Notice of Modification

Section 75W of the *Environmental Planning and Assessment Act 1979*

Project application 06_0239 made by ThaQuarry Pty Ltd & ACN114 843 453 Pty Ltd, in relation to Lot 10 DP 241 859, Lot W DP 419 612, Lot 1 DP 400697 & Lot 2 DP 262213, Eastern Creek in the Blacktown local government area.

Eastern Creek Waste Project.

APPENDIX 1 – Site Plan

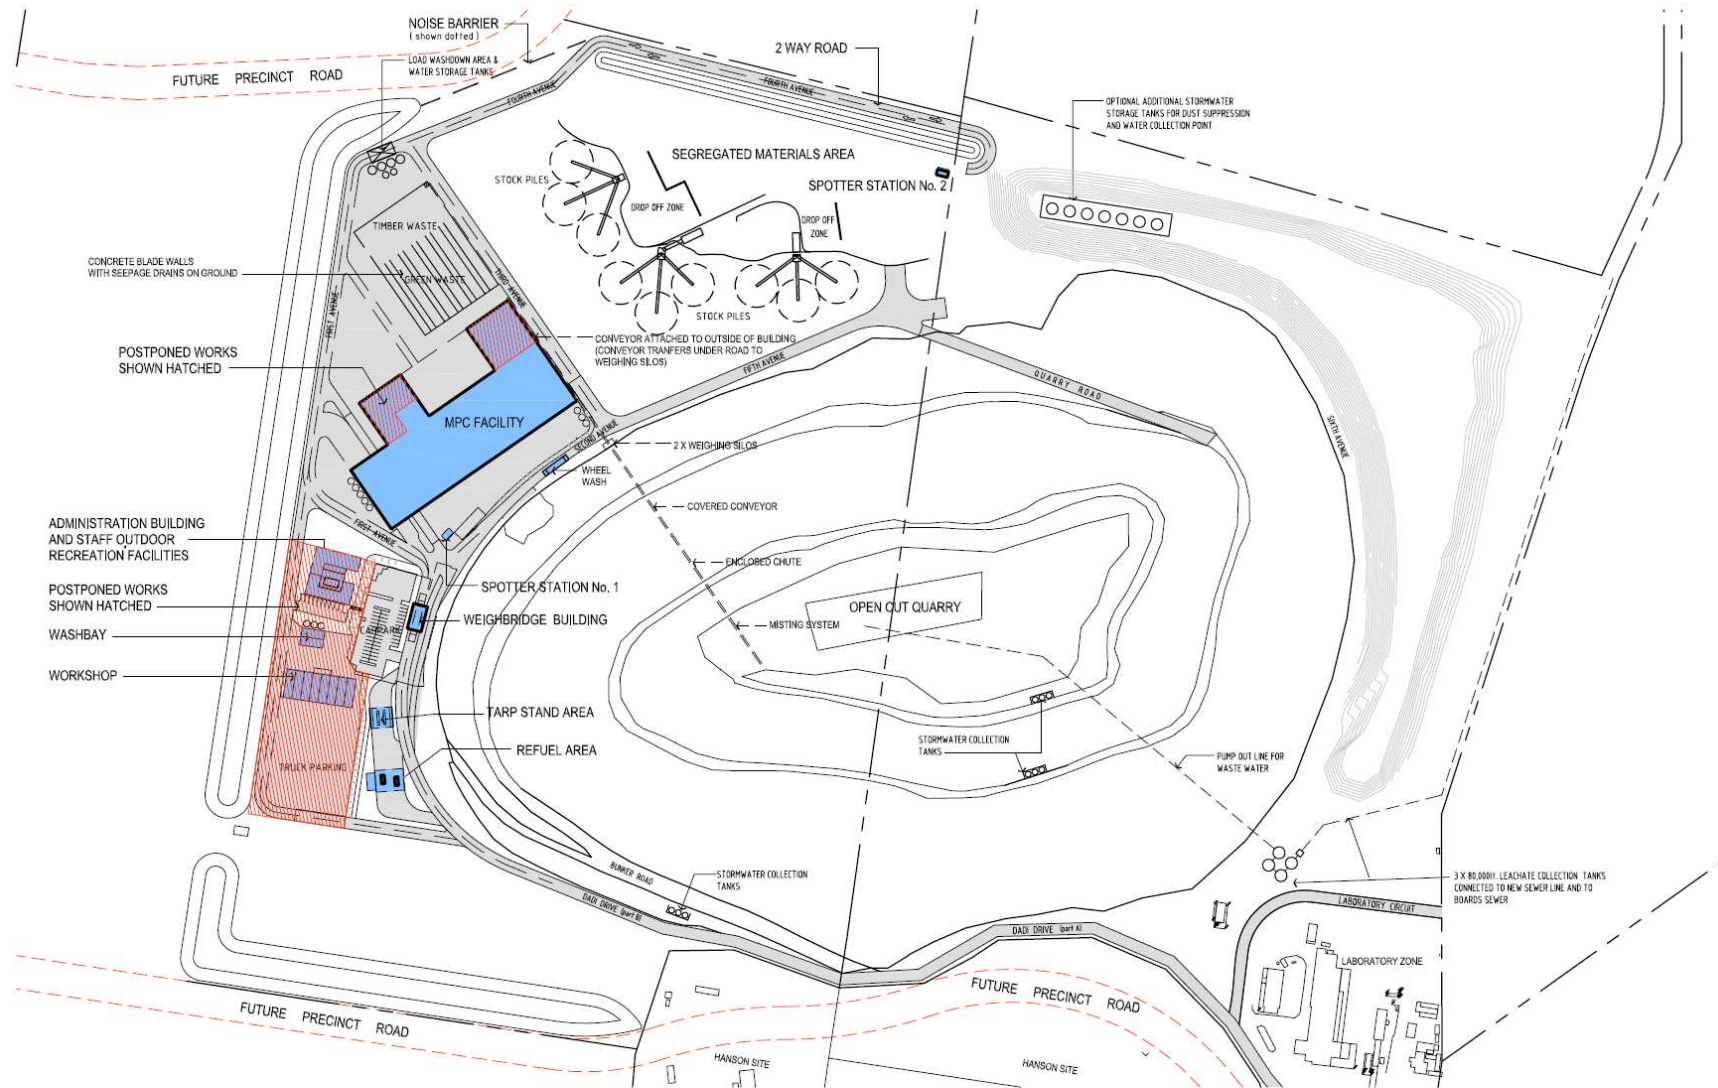
11. Replacing existing Site Plan in Appendix 1 with new Site Pan.
